XK

TECHNICAL BULLETIN

**Ticking Noise From Left side Footwell –
EVAP Canister Purge Valve –
Repair Procedure**

MODEL 2003-05 MY
XK Range
VIN A30645-A40920

ILLUSTRATION 3

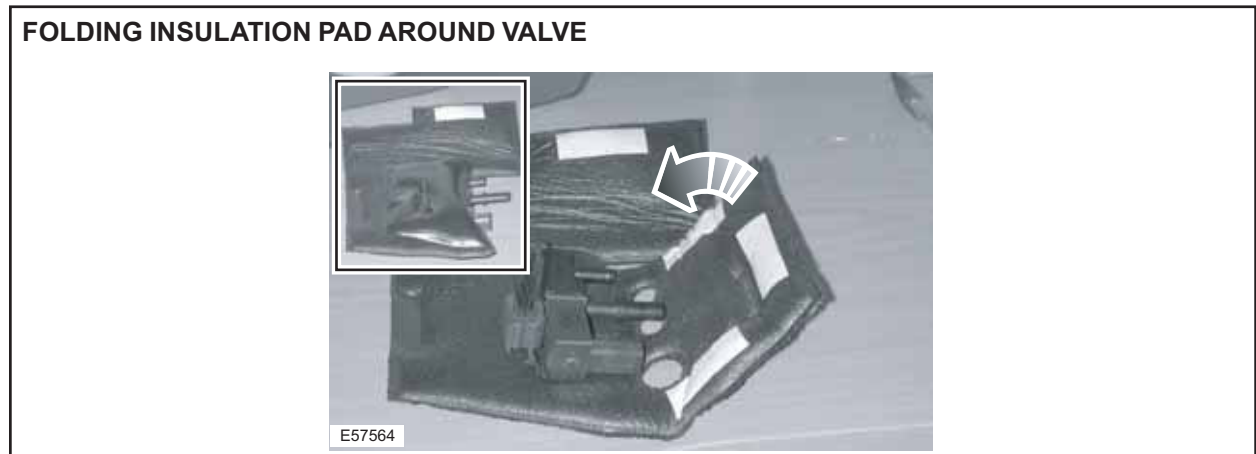
1. Remove the EVAP canister purge valve (see Global Technical Reference GTR Workshop Manual, section: 303-13, SRO 17.15.30).
2. On those vehicles that have an EVAP purge valve without a link lead, discard the purge valve and obtain the new style valve with the link lead. (VIN ranges of A30645 to A36998 on N/A vehicles and A30645 to A37134 on SC vehicles). If the existing valve has a link lead, retain the valve and continue with the procedure.
3. Insert the EVAP canister purge valve into the new insulation pad, fold the insulation pad around the EVAP canister purge valve and secure (Illustration 3).

ILLUSTRATION 4

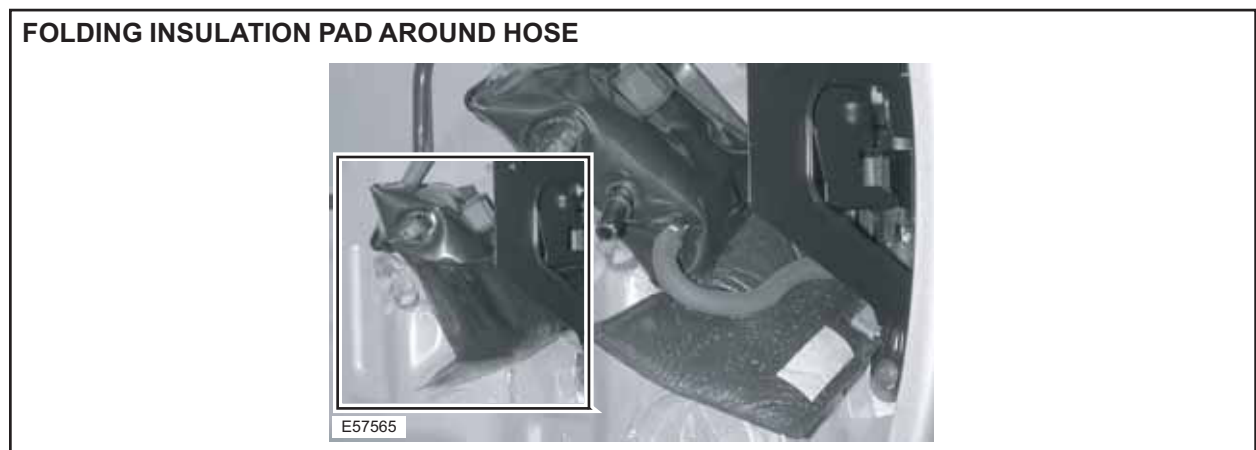
Note: When installing the EVAP canister purge valve on the vehicle, connect the lower hose to the valve and fold insulation pad around the lower hose and secure (Illustration 4).
